Subject: Byron Ultimate Heat Sink
 Byron Units 1 and 2,
 NRC Docket Numbers 50-454 and 50-455

Byron/Braidwood UFSAR Change Log

Byron/Braidwood
 UFSAR Change Log
 DRP 4-009

FIGURE 9-2-14

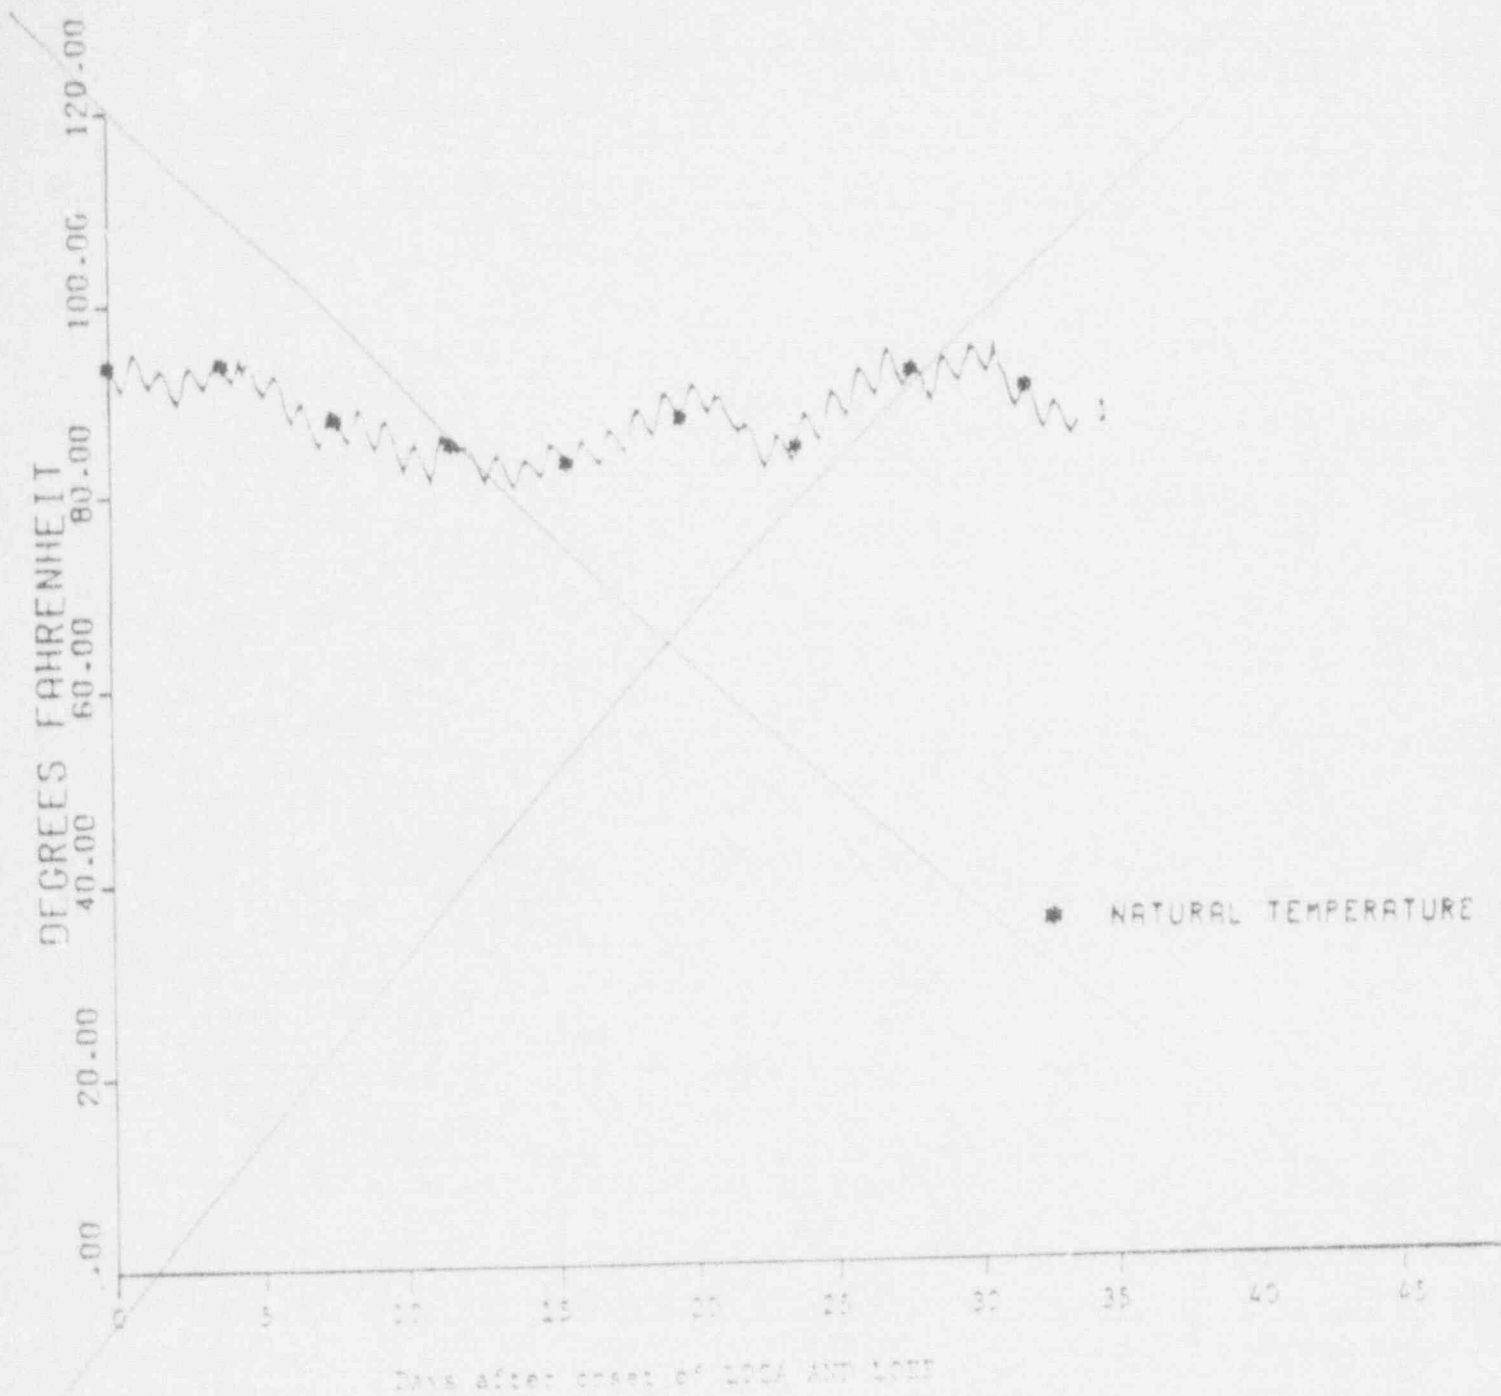
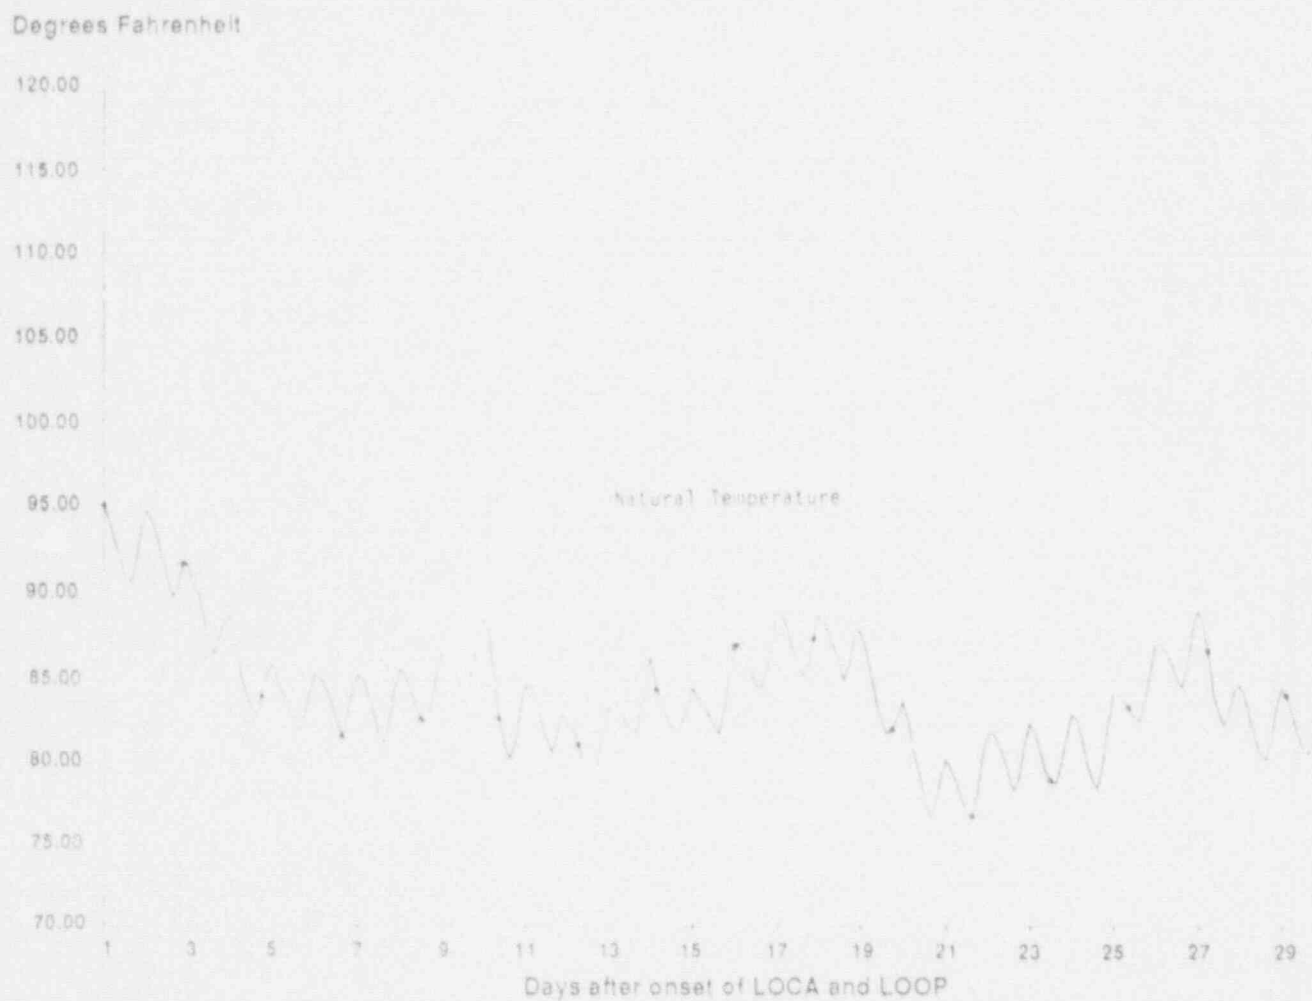
9.0	9.0-xvi	Denote Figures 9.2-9 through 9.2-14 as applying to Braidwood only, add Figures 9.2-30 and 9.2-31	Editorial	Changes are per this DRP
9.2.1.2.1	9.2-2	Revise section	Reflect design basis	IHS Final Report

Section	Page	Description of Change	Reason/Basis	References/Remarks
9.2	F9.2-7	Revise Figure 9.2-7	Document calculation results	Calculation ATD-0063, Revision 1, dated April 1, 1992
9.2	F9.2-8 to F9.2-14	Change Figures 9.2-8 through 9.2-14 to 'Braidwood Only'	Editorial	Byron does not have a cooling pond
9.2	F9.2-9 to F9.2-14	Replace Figures 9.2-9 through 9.2-14	Document calculation results	"Thermal Performance of the Ultimate Heat Sink During a Loss of Coolant Accident," S&L Calculation ATD-0109, Revision 1, April 27, 1992
9.2	F9.2-30	Add Figure 9.2-30	Document calculation results	Calculation RSA-B-91-03, Figure 14
9.2	F9.2-31	Add Figure 9.2-31	Document calculation results	Calculation RSA-B-91-03, Figure 15

Replace with a new figure
